MARINE ENVIRONMENT PROTECTION
COMMITTEE
59th session
Agenda item 4

MEPC 59/4/12
9 April 2009
Original: ENGLISH

Consideration of the Energy Efficiency Design Index for New Ships

Refinements to the “draft guidelines on the method of calculation of the energy efficiency design index for new ships” for conventional passenger ships

Improved diagram

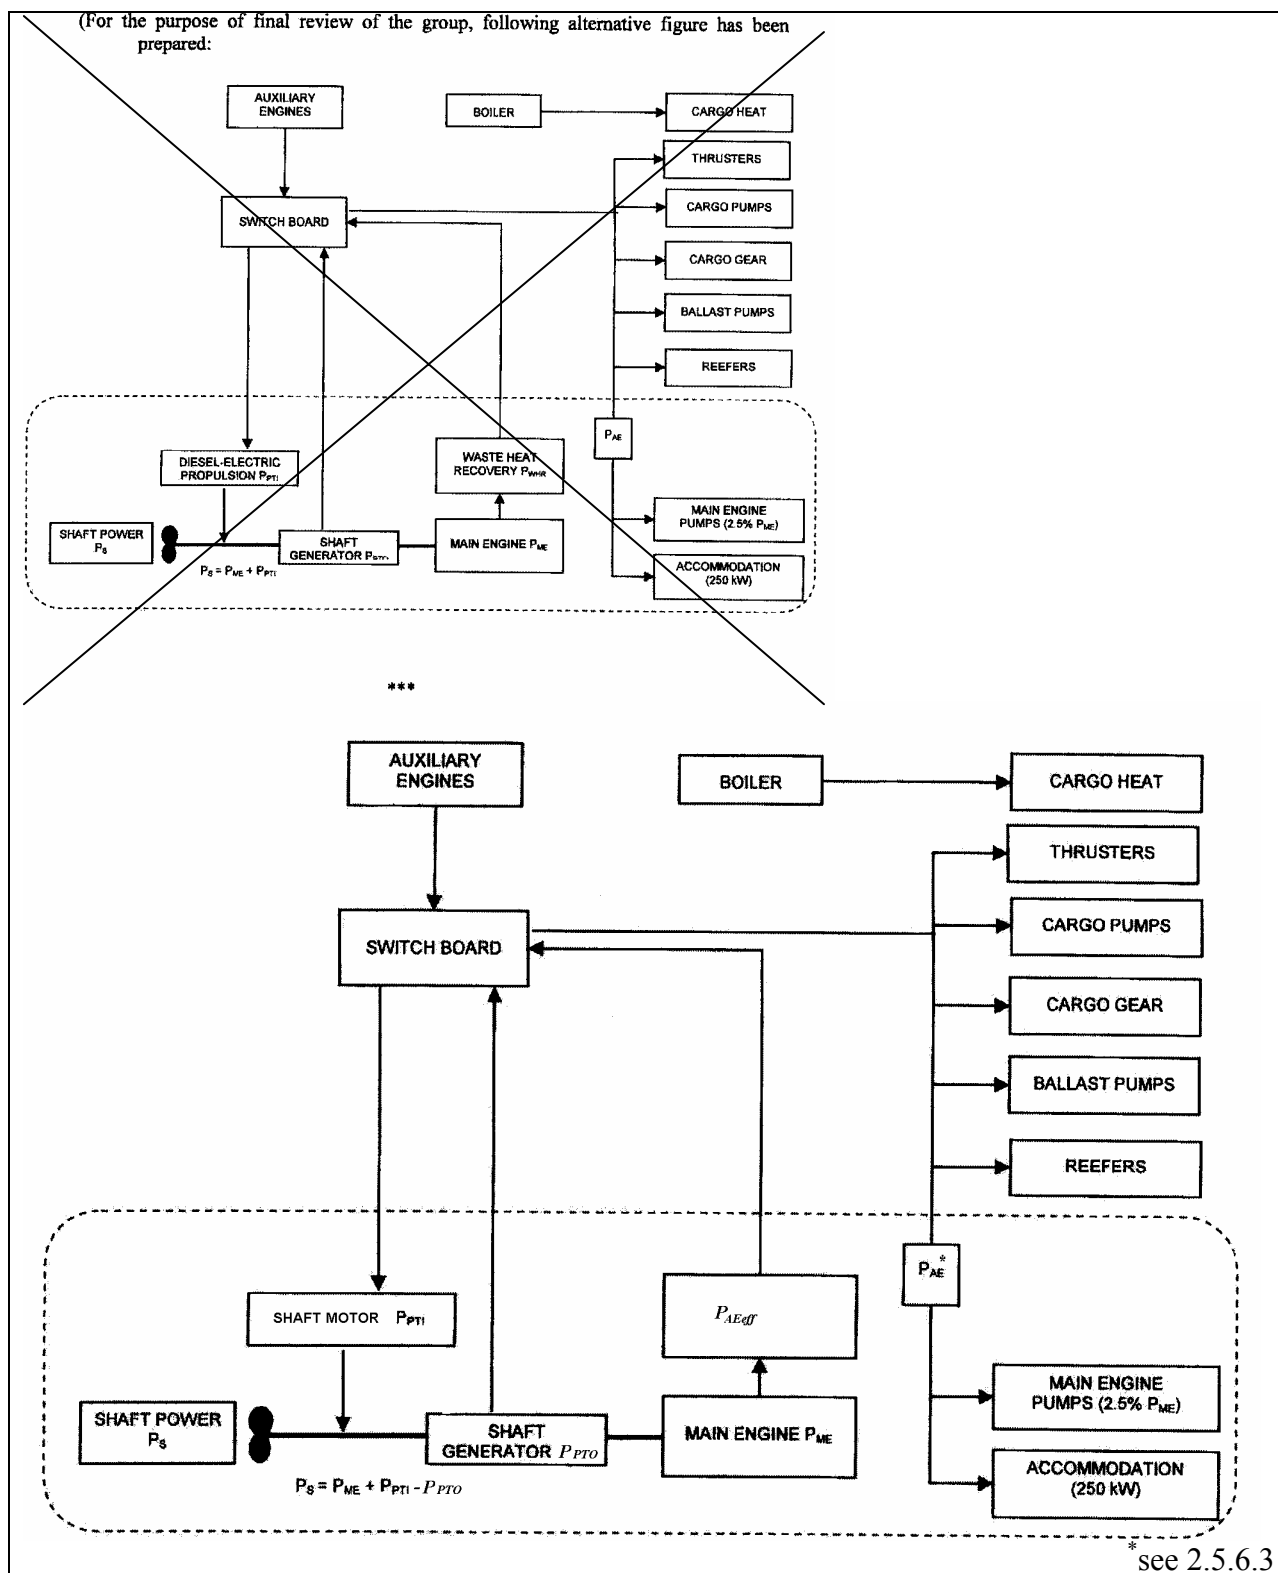
28 CLIA suggests that the current explanatory diagram would benefit from additional refinement to provide consistency with the detail of the EEDI formula. A proposed revision to achieve consistency with the EEDI calculation is provided below.

Amendments to page 7

(For the purpose of final review of the group, following alternative figure has been prepared:
